Access Compliance Report

Public Rights-of-Way

Intersection ID: 24896	Main Street: GADWALL_CT	Cross Street: KING_EIDER_DR	Location: SE
ADA ID: 2EA5D48D51AA	Ramp Type: Directional1	Initial Pass/Fail: Fail	Overall Compliance: No
Severity Score: 1.25			
Codes/Mitigation Info/Possible Solution		Field Measurements/Component Compliance

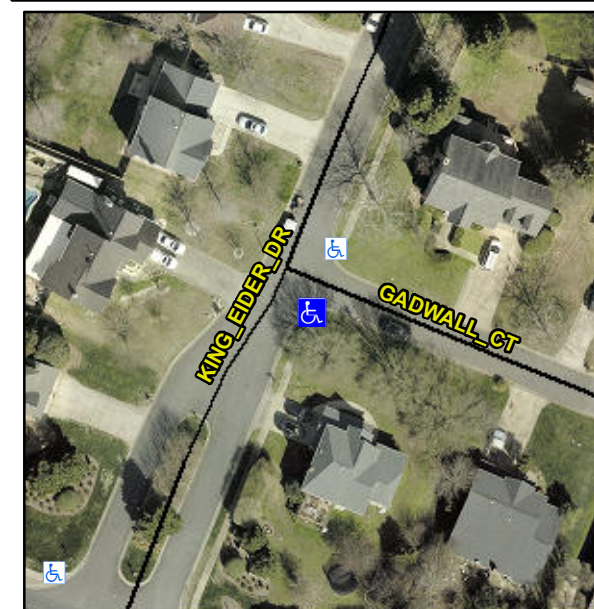
R304.5.3

Compliance	Description	Data	Compliance	Description	Data
N/A	Ramp Length (in)	30.0	N/A	Grade Break?	N/A
Yes	Ramp Width (in)	48.0	N/A	Grade Break Slope (%)	0.0
Yes	Ramp Slope (%)	7.6	N/A	Grade Break XSlope (%)	0.0
No	Ramp XSlope (%)	3.6			
N/A	Flare Type LT	N/A	N/A	Flare Type RT	N/A
N/A	Flare Slope LT (%)	N/A	N/A	Flare Slope RT (%)	0.0
N/A	Flare Traversable LT?	N/A	N/A	Flare Traversable RT?	N/A
N/A	Landing Length (in)	0.0	N/A	DWS Provided?	N/A
N/A	Landing Width (in)	0.0	N/A	DWS Contrast?	N/A
N/A	Landing Slope (%)	0.0	N/A	DWS Length (in)	N/A
N/A	Landing X Slope (%)	0.0	N/A	DWS Full Width?	N/A
N/A	Landing Curb? (Y/N)	N/A	N/A	DWS Offset LT (in)	N/A
N/A	Shared Landing?	N/A	N/A	DWS Offset RT (in)	N/A
N/A	Gutter Ponding?	0.0	N/A	Gutter Slope (%)	N/A
N/A	Gutter Lip Ht (in)	0.0	N/A	Gutter X Slope (%)	N/A
N/A	Painted X Walk1?	No		Road Slope (%)	2.8
	X Walk 1 Direction	To N		Road X Slope (%)	3.7
	X Walk 1 Width (in)	N/A		Clear Space?	N/A

Remove & Replace Entire Ramp.
